Addendum No. 2
Merrill Virtual Learning Center
Berrien Springs Public Schools

29 December 2020

This addendum forms a part of the Contract Documents and modifies the original Bidding Documents (PROJECT MANUAL dated **07 December 2020**). Please acknowledge receipt of this Addendum when submitting your bid. This Addendum has been distributed to the plan holders of record only. It is the bidder's responsibility to distribute Addendum information to subcontractors and material suppliers. This Addendum reflects modifications from the Owner, Architect, and Bidders.

A1.1

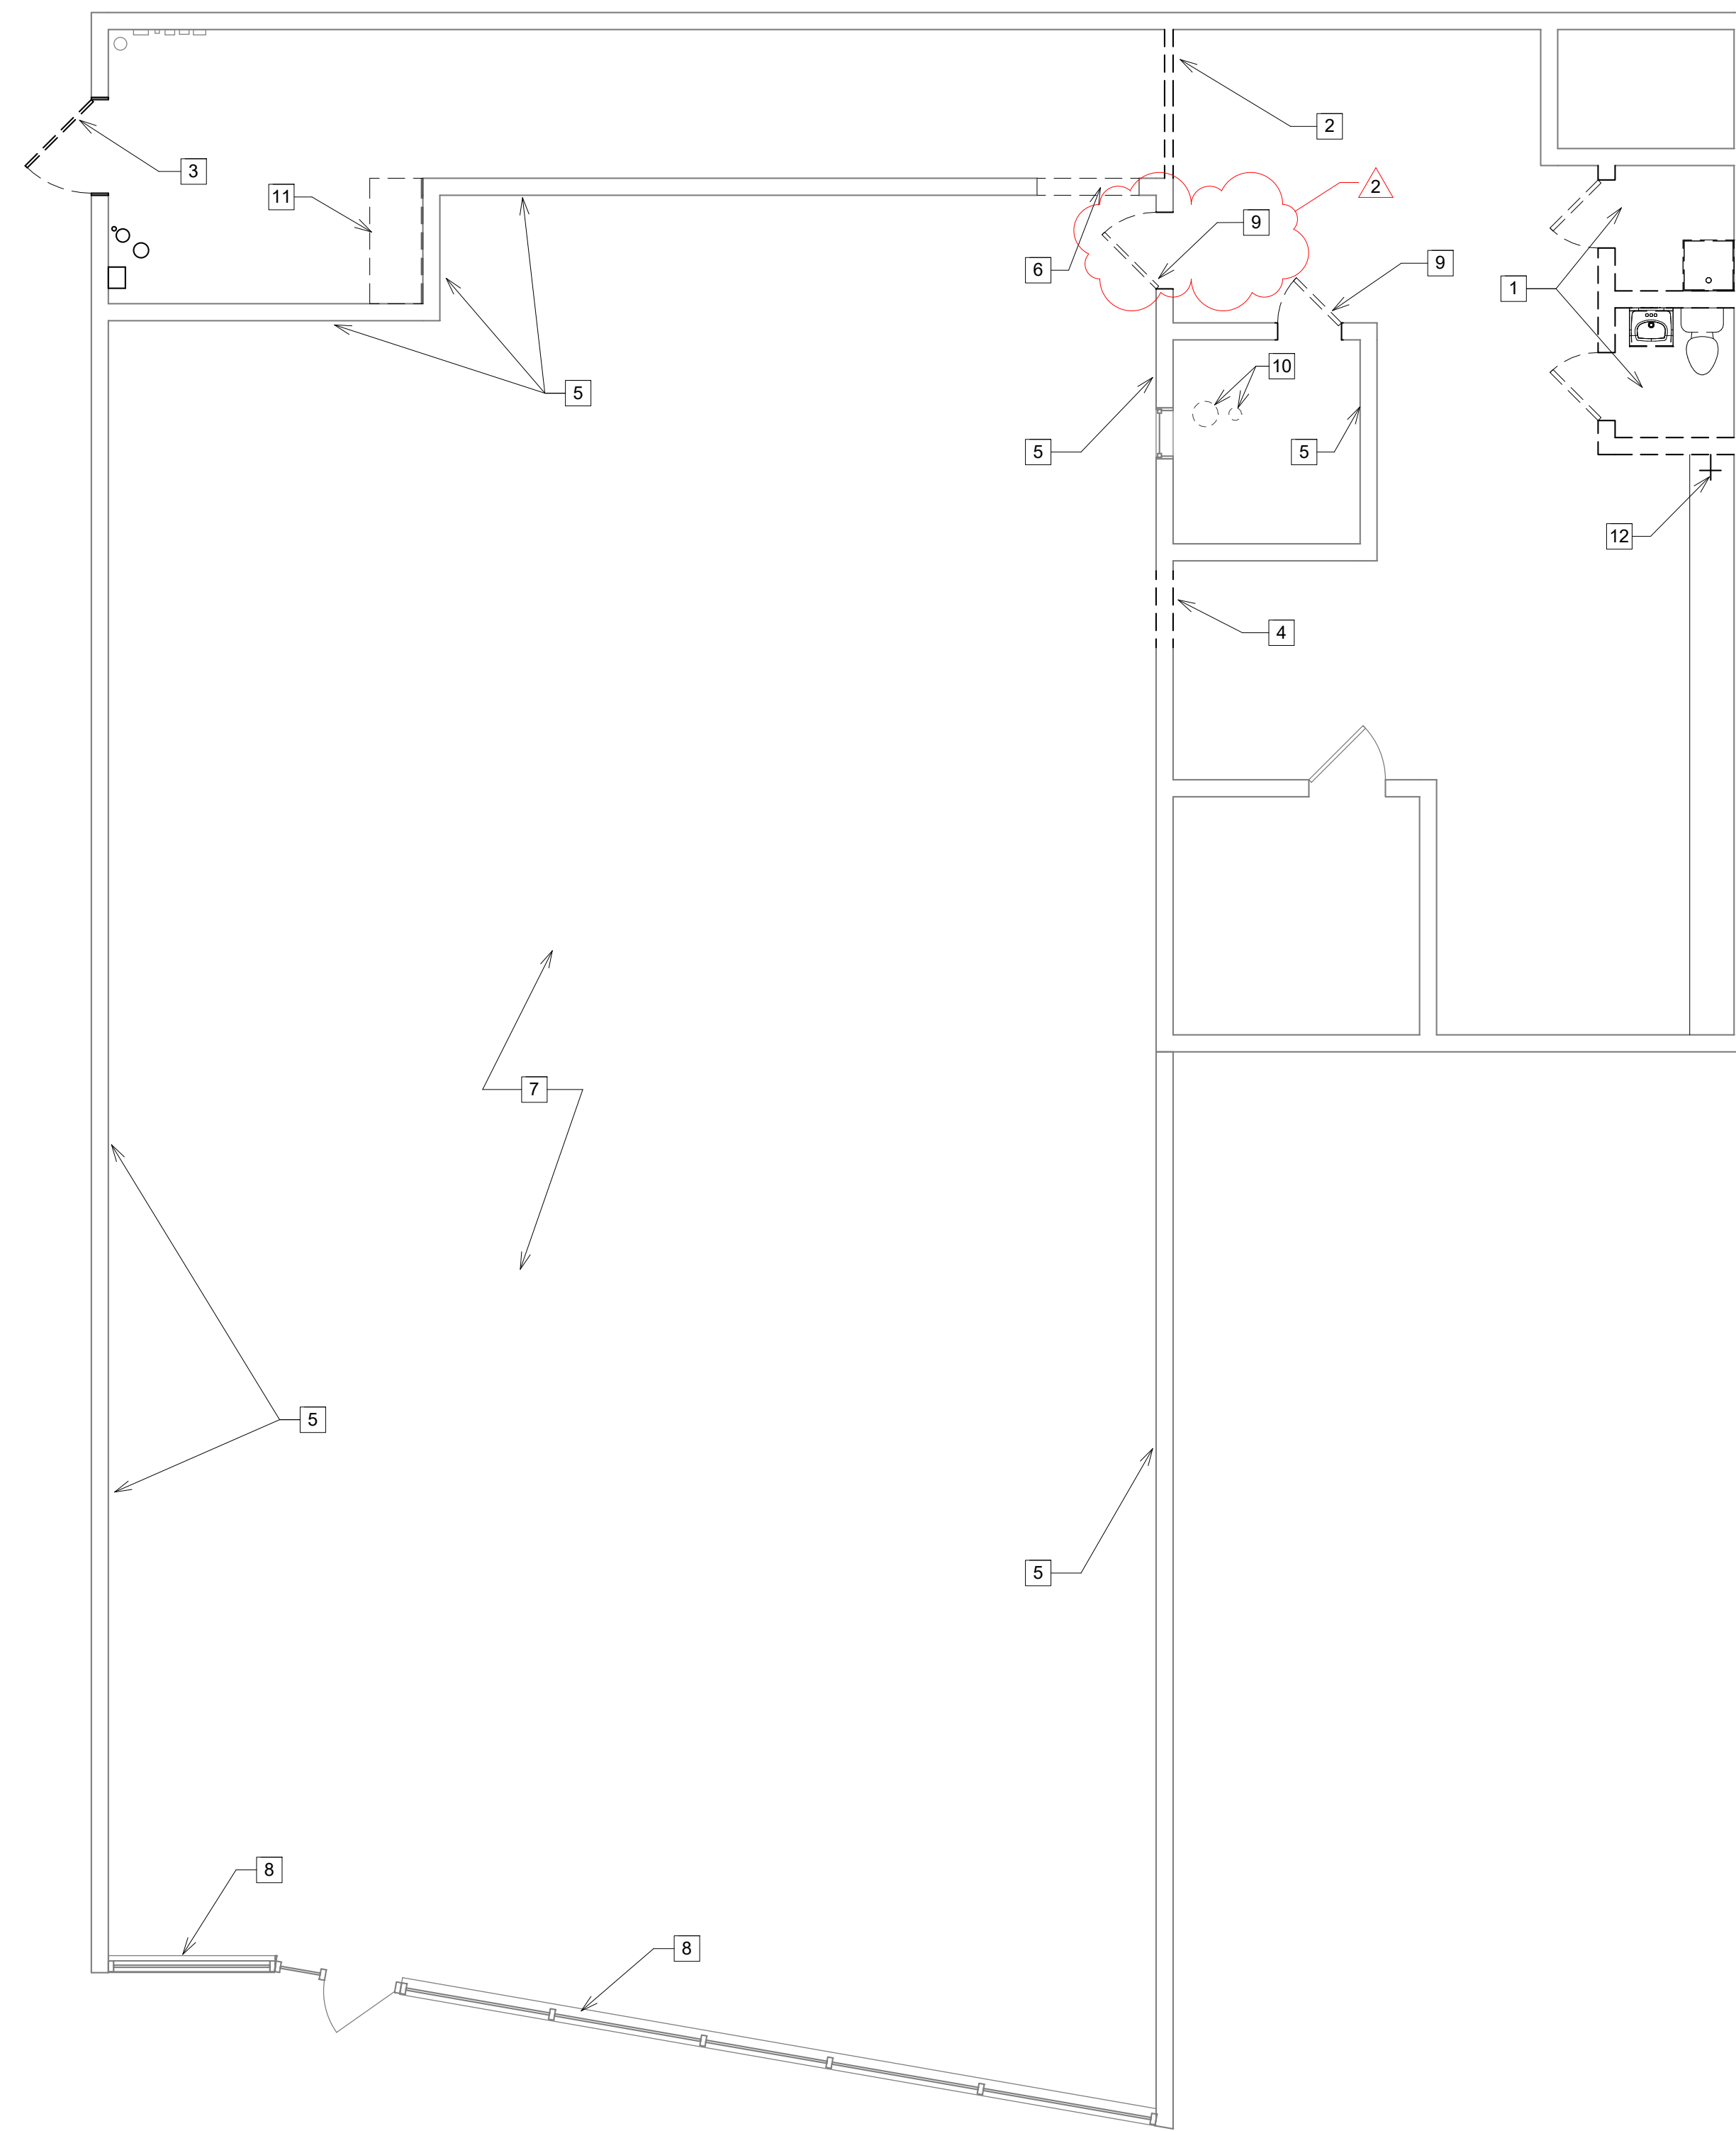
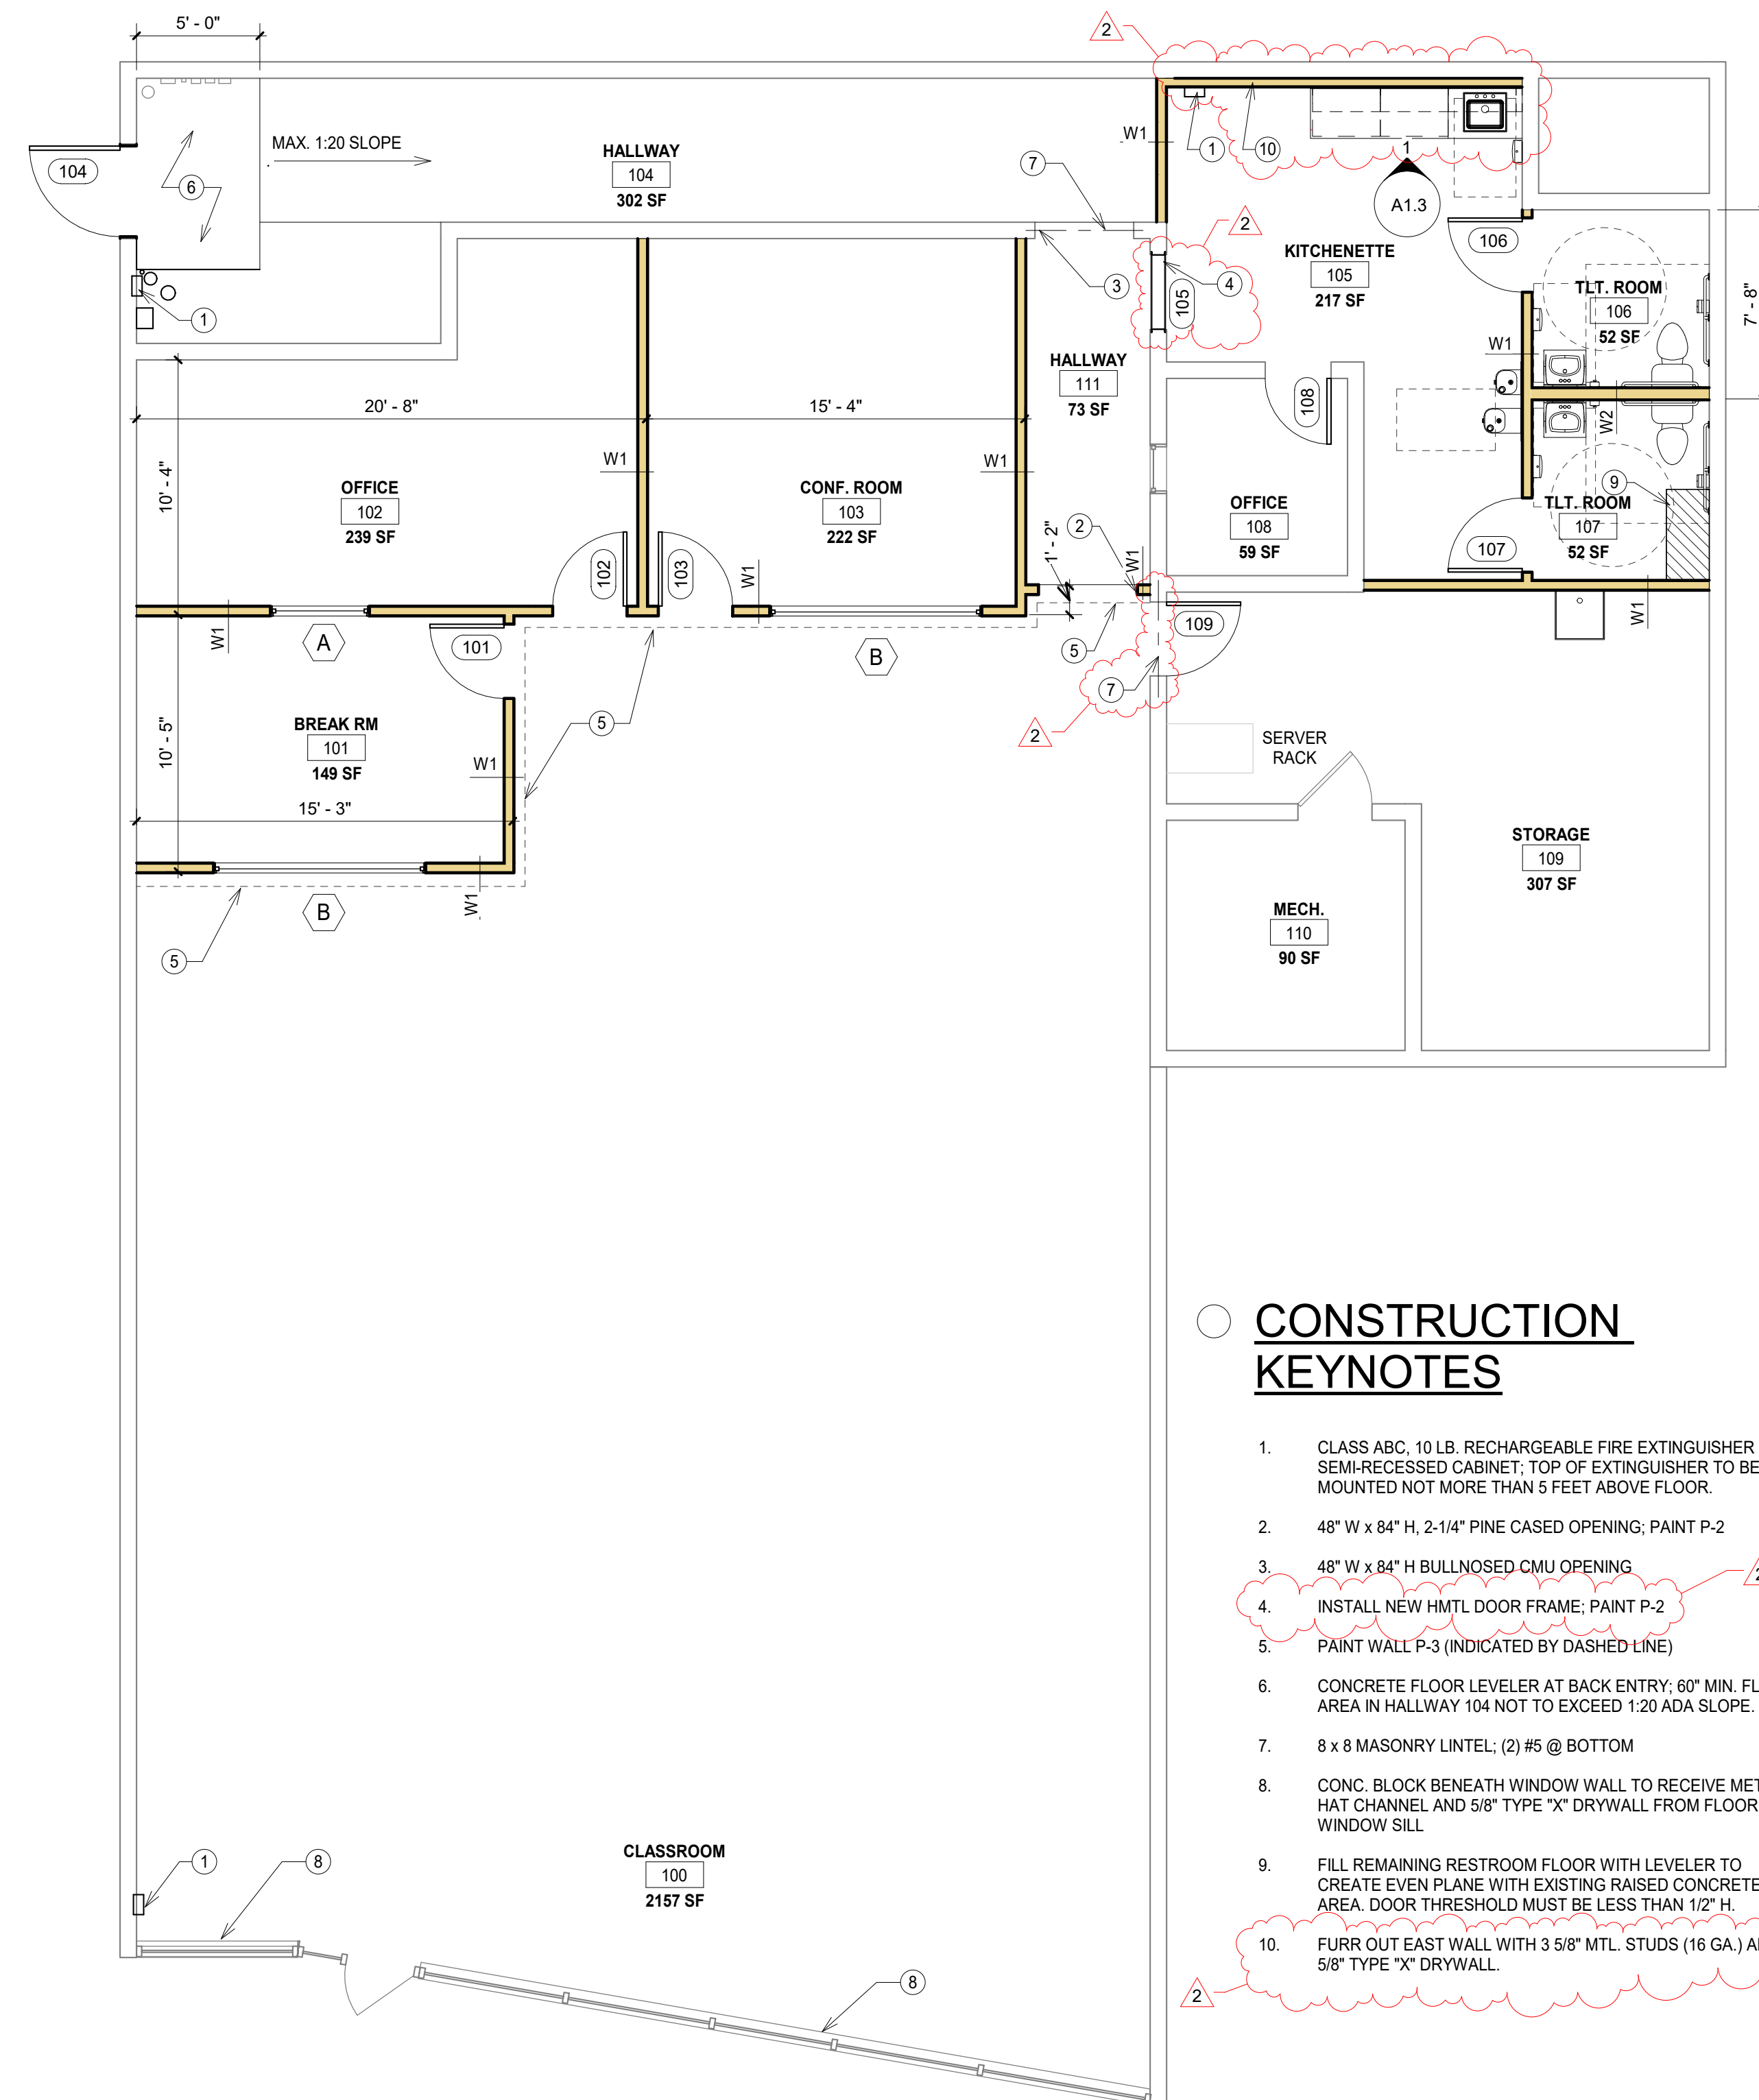
1. Sheet A1.1 Demolition and Construction Plans:
 - a. The new door at Storage 109 should be marked with Construction Keynote #7; 8 x 8 masonry lintel, (2) #5 @ bottom.

- b. The east wall of the Kitchenette will be furred out with 3-5/8" metal studs (16 ga.) and 5/8" type "X" drywall to accommodate recessed electrical boxes.
